ATTACHMENT 4

PROPOSED TECHNICAL SPECIFICATION CHANGES
FOR QUAD-CITIES 2

QUAD-CITIES
DPR-30

1.1/2.1 FUEL CLADDING INTEGRITY

FIGURE 2.1-1

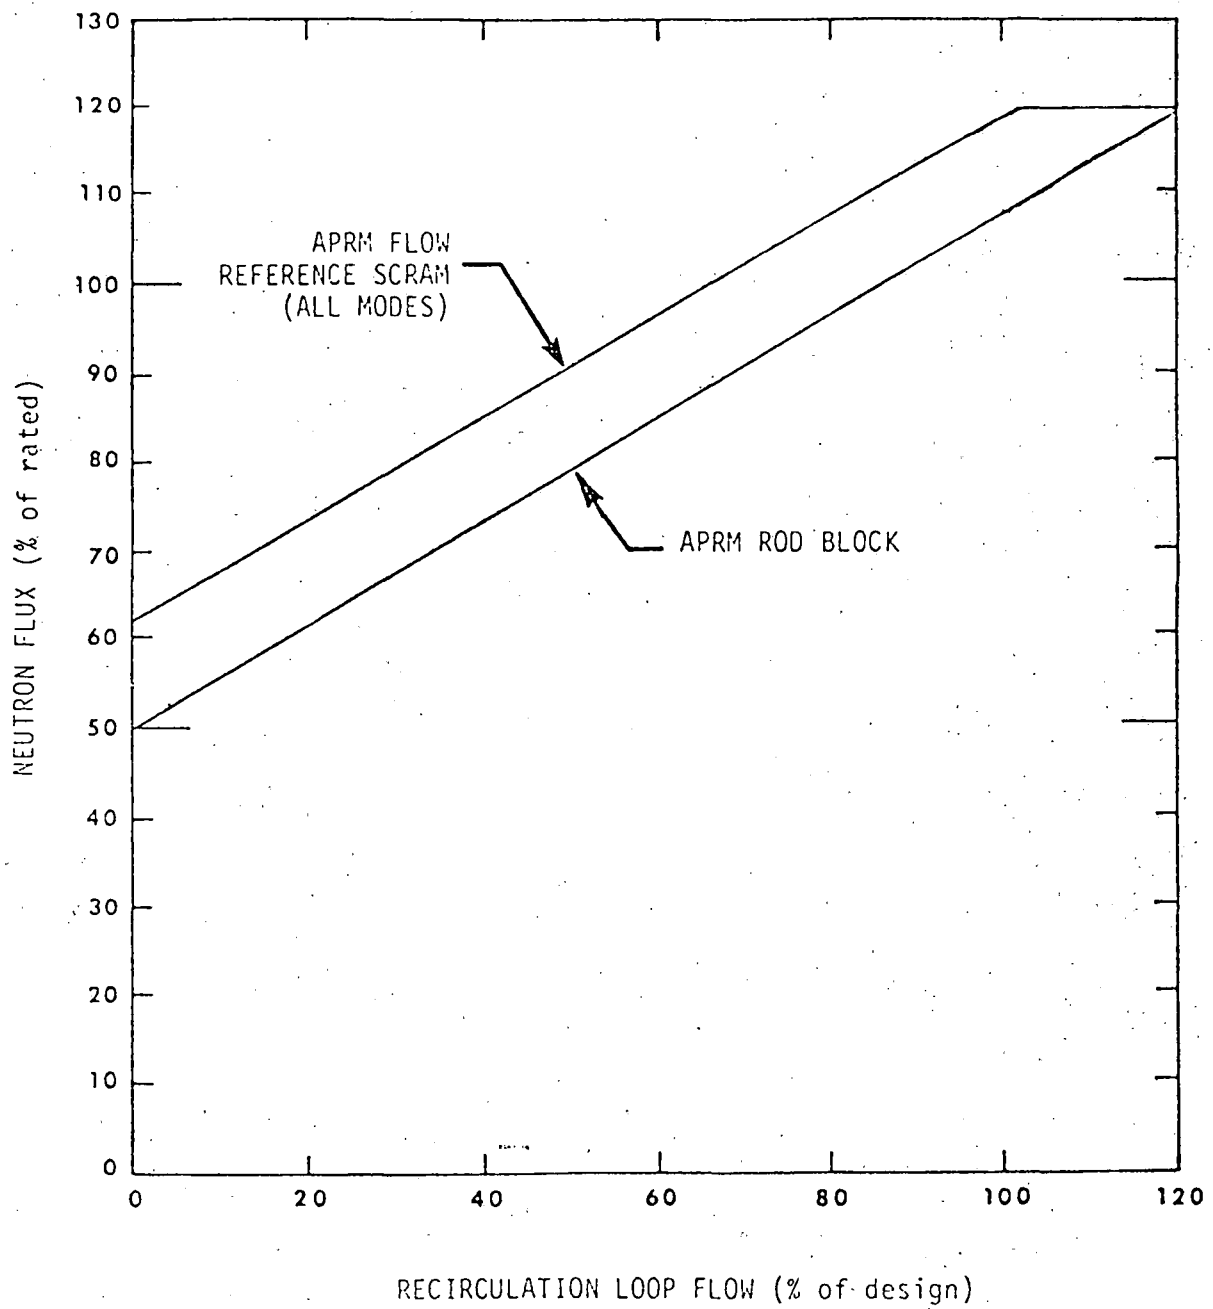
When the reactor mode switch is in the Run position, the APRM flux scram setting shall be as shown in Figure 2.1-1 and shall be:

$$S \leq (0.58W_D + 62) \quad (LTPF/TPF)$$

with a maximum setpoint of 120% for core flow equal to 98×10^6 lb/hr and greater.

The APRM rod block setting shall be as shown in Figure 2.1-1 and shall be:

$$S \leq (0.58W_D + 50) \quad (\text{LTPF/TPF})$$
